ADDENDUM No. 1

RFP No. 23-19

Crescents Phase 1 Water Main Replacement and Resurfacing

DRAWING No. 2022012-9

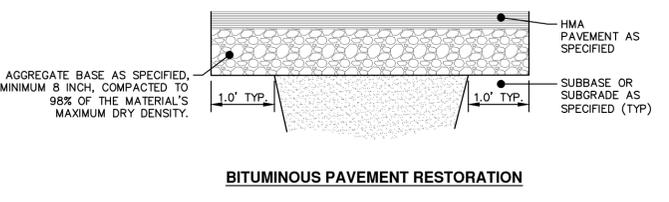
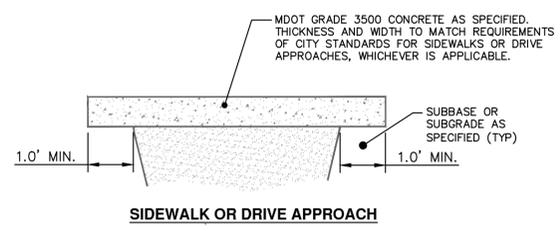
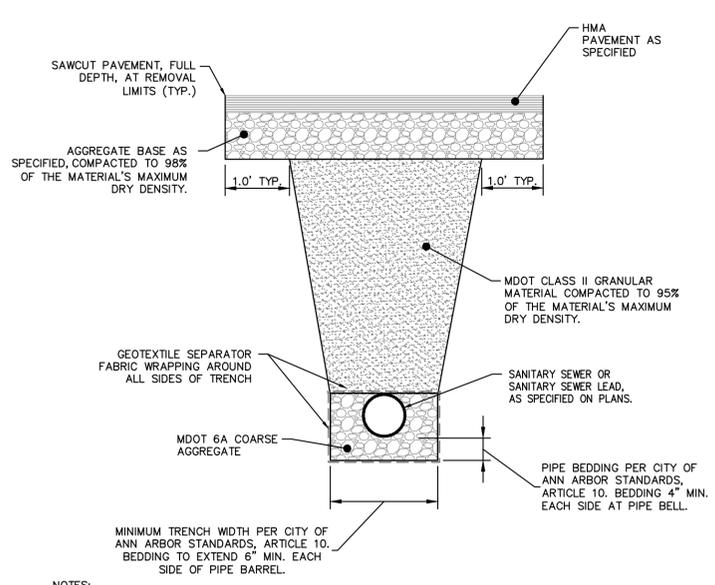
Section/Page(s)	Change
Plans 9	Detail Sheet relabel Trench Detail 1 and Added Trench Detail 1B for sanitary sewers, revised SD-TD-#3A.
Plan 11-13	Revised Cross Section to only show 21 AA aggregate base within the water main trench restoration.
Schedule of Prices	Minor quantity revisions, shown as bold.
Wage Decisions	Heavy MI 20230074 02/03/2023 and Highway MI 20230001 03/17/2023 wage decisions in effect for the project as references documents can be downloaded from Sam.Gov
New Content 1-2	Pre-Proposal Meeting 4-6-2023 Minutes

SCALE PLAN: 1" = 4'
DRAWING No. 2022012-11

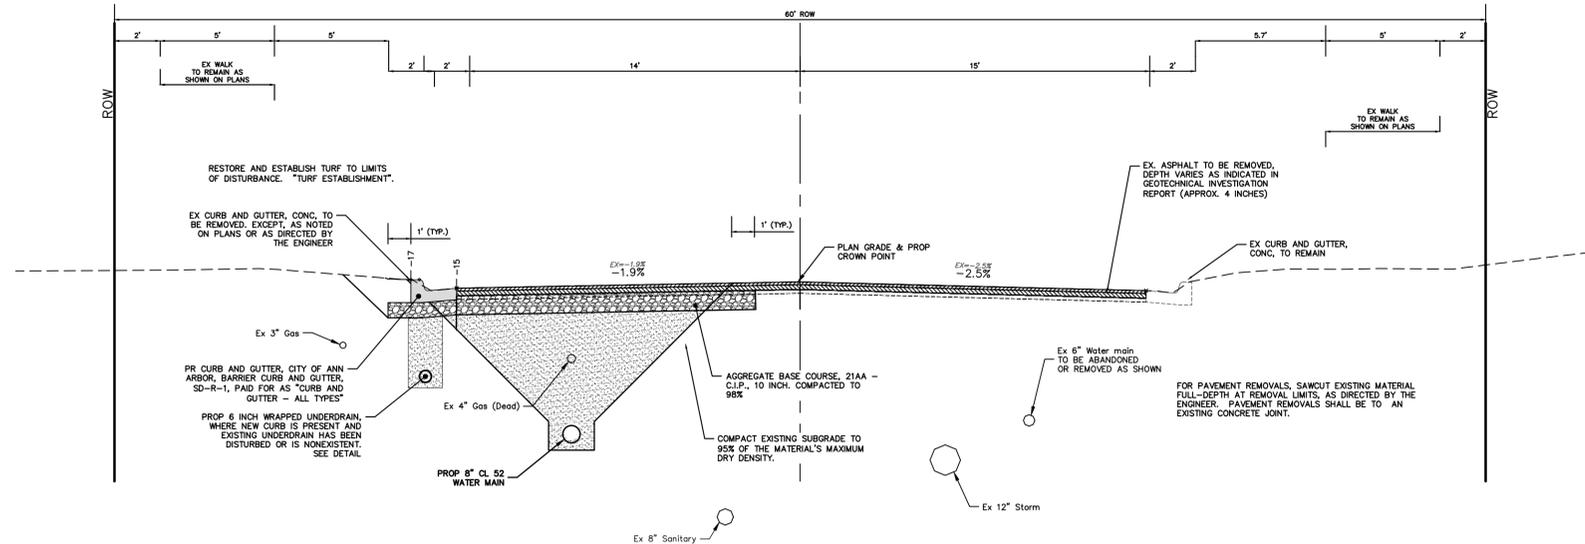
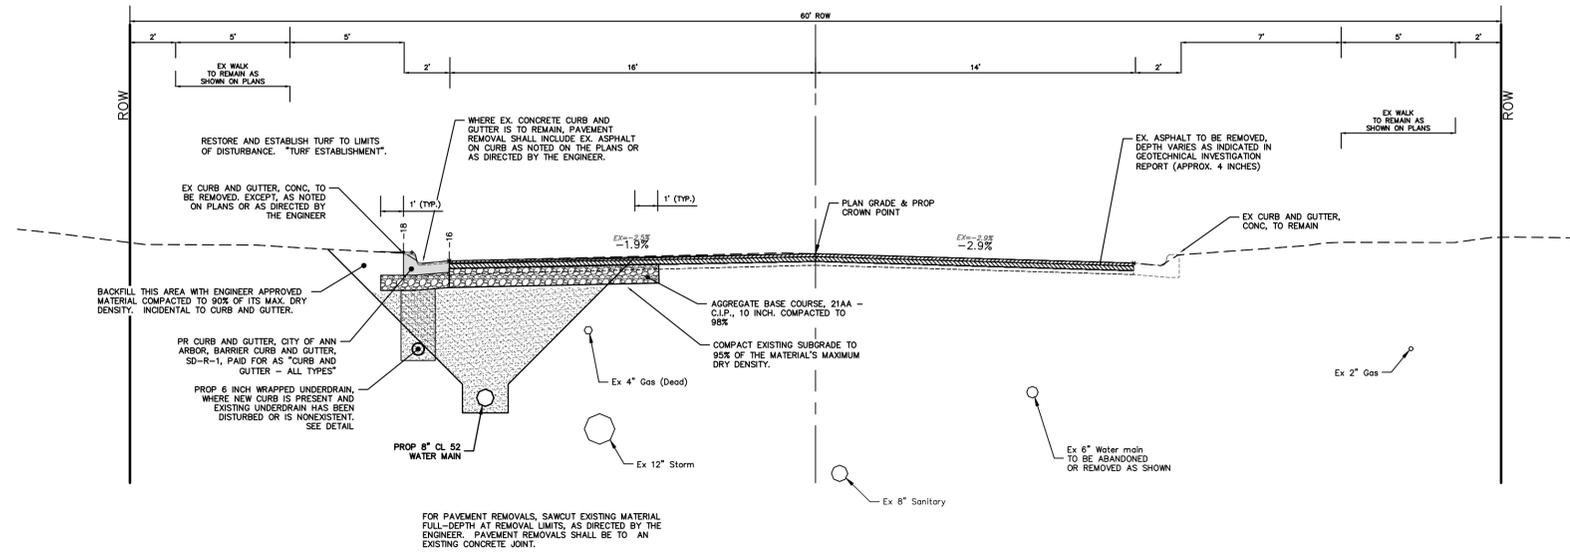
Answer 2: CLII sand needs to meet MDOT Specification
- Question 3: Clarify is the intent to excavate and place 21AA aggregate outside of the water main trench excavation?

Answer 3: Our intention is to only place 21 AA over the water main trench, and water service trenches, and work with existing material under the pavement outside the trench restoration. The cross-section detail shows cleaning up the edge of the WM trench so the 21AA has a clean edge. See Revised Cross-sections
